**CITY OF BATON ROUGE
PARISH OF EAST BATON ROUGE
DEPARTMENT OF ENVIRONMENTAL SERVICES**

ADDENDUM NO. 2

SUBJECT: **HOOPER ROAD PUMP STATION PROJECT
CITY-PARISH PROJECT NO. 10-PS-GS-0048**

SHEET NUMBER		R-C01R	
EAST BATON ROUGE		BATON ROUGE	
DESIGNED	CHKD	DATE	BY
BKR	JRS	04-01-2016	JRS
Detailed	Checked	131	
PROJECT		10-PS-MS-0048	
ADDED NOTES 4-7: REMOVED "BY OTHERS"		REVISION DESCRIPTION	
NO.		DATE	
1		05/31/16

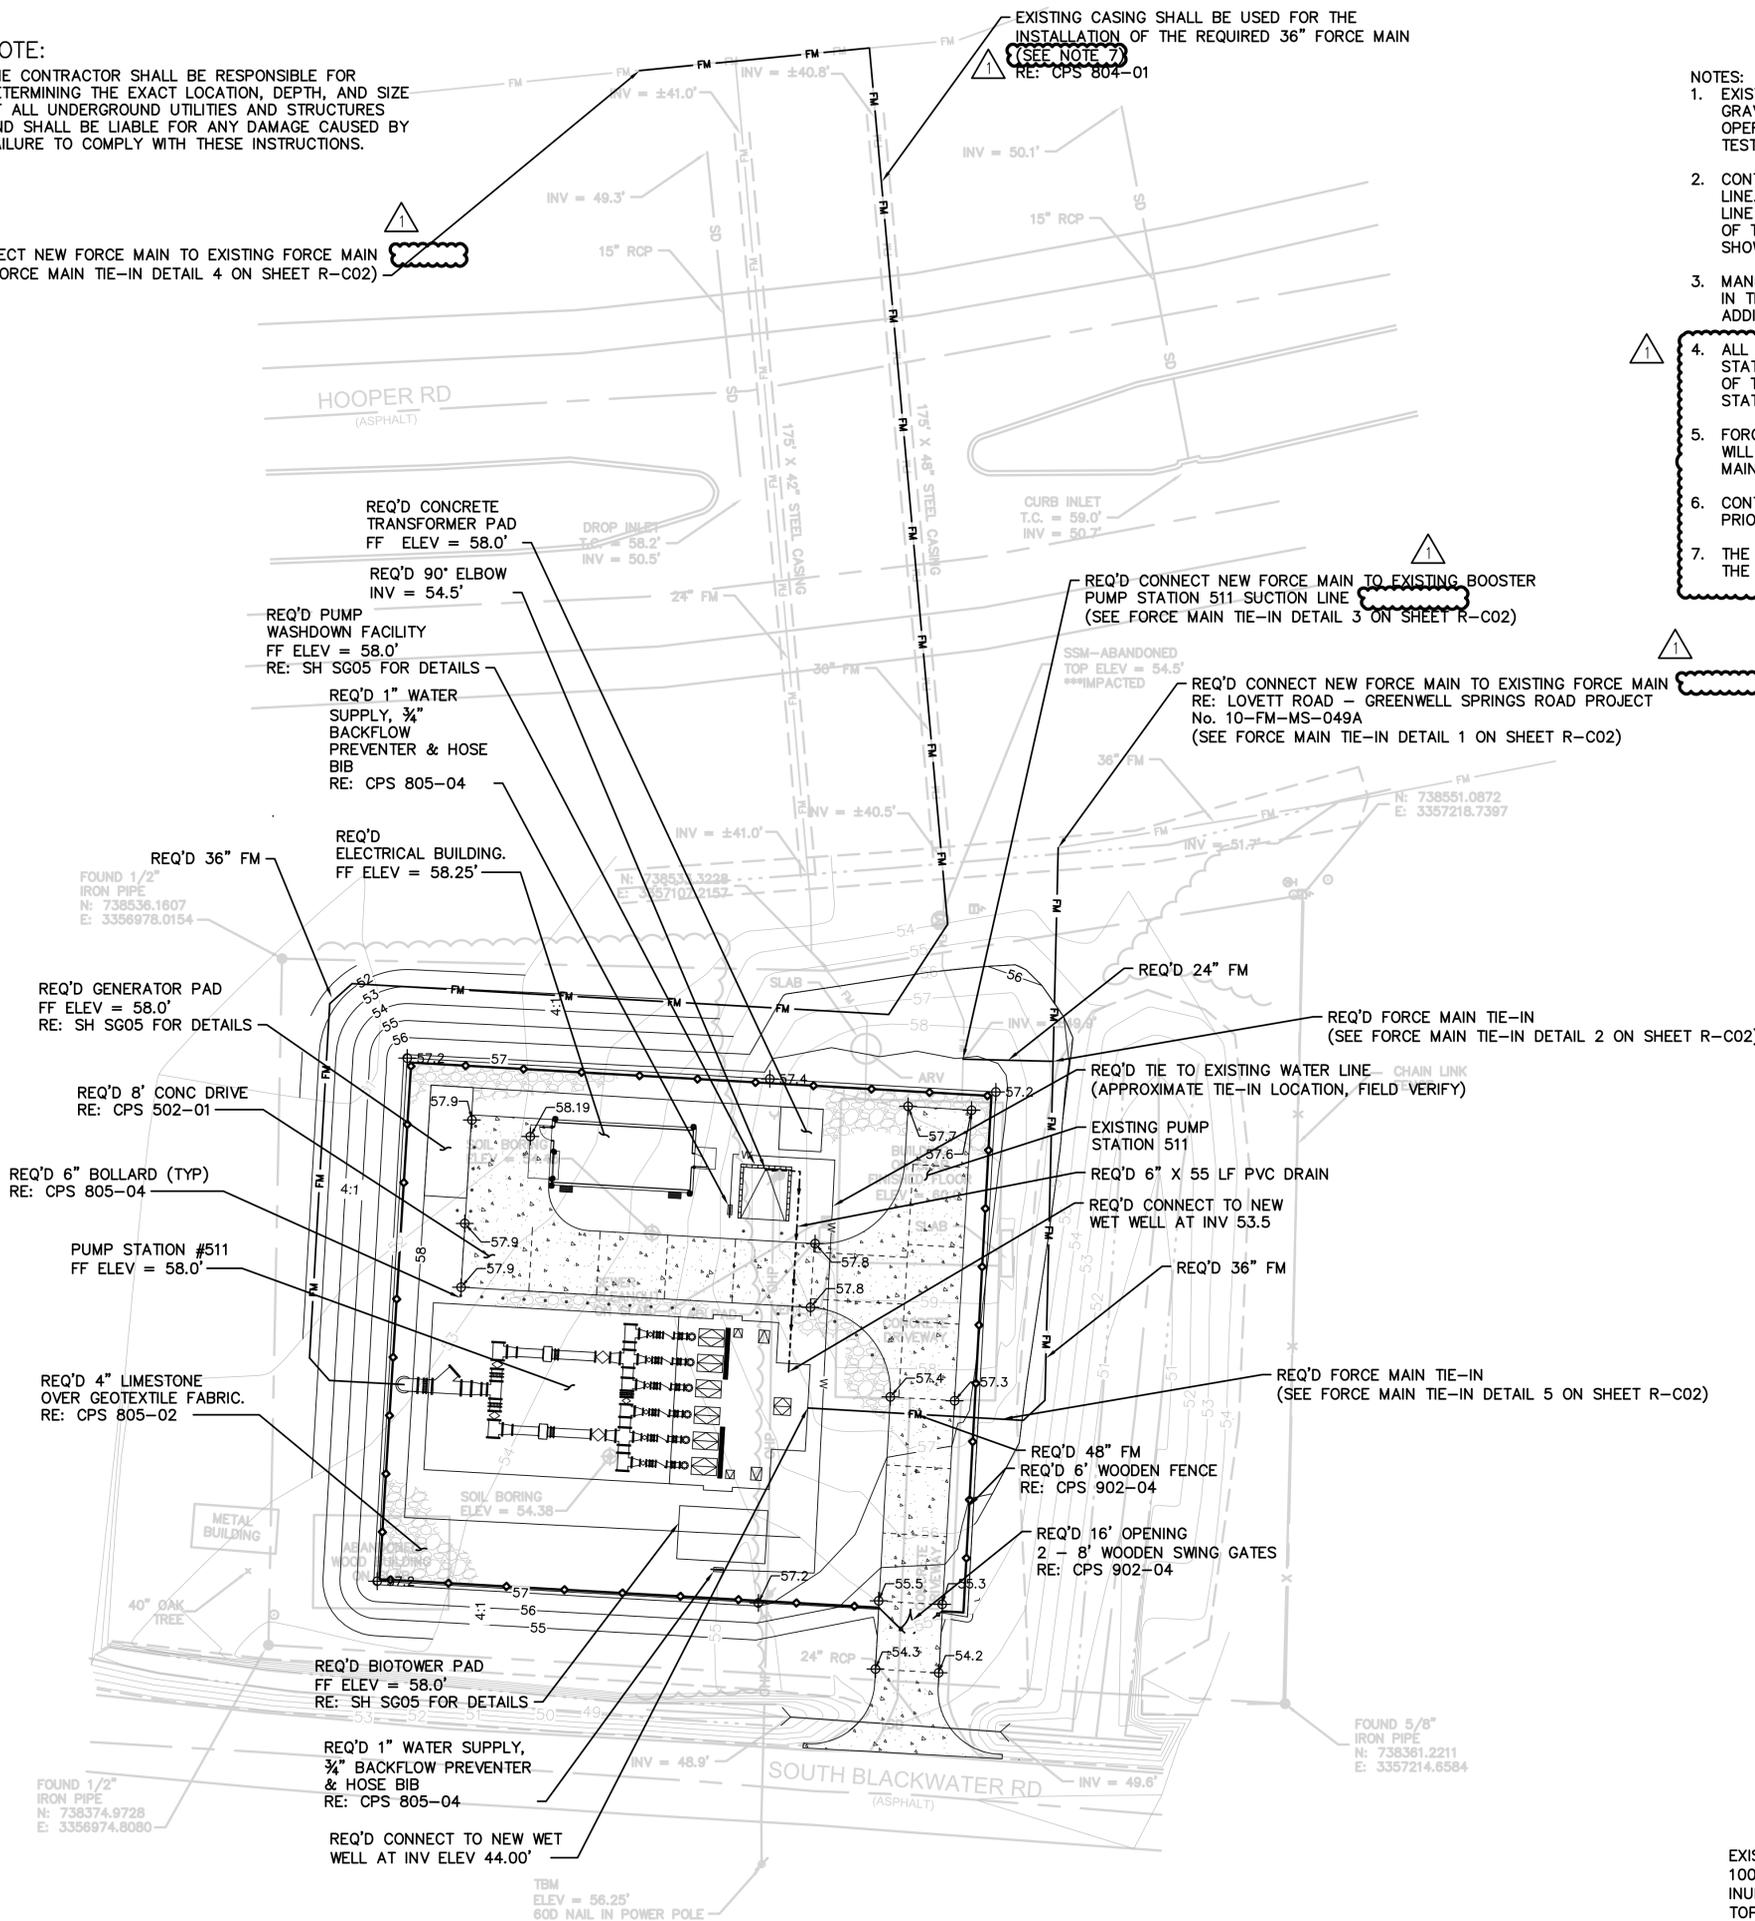
25. Drawing P-C01, Q-C01 and R-C01 state at force main tie-in locations "Req'd connect new force main to existing force main (by others)." Bid items 804920A thru 804920Q, 804921B thru 804921Q and 804922B are all for force main tie-ins. Please clarify as to who will be performing the sewer force main tie-ins.

The tie-ins are included in this contract. See revised plan sheets in this addendum.

REQ'D CONNECT NEW FORCE MAIN TO EXISTING FORCE MAIN (SEE FORCE MAIN TIE-IN DETAIL 4 ON SHEET R-C02)
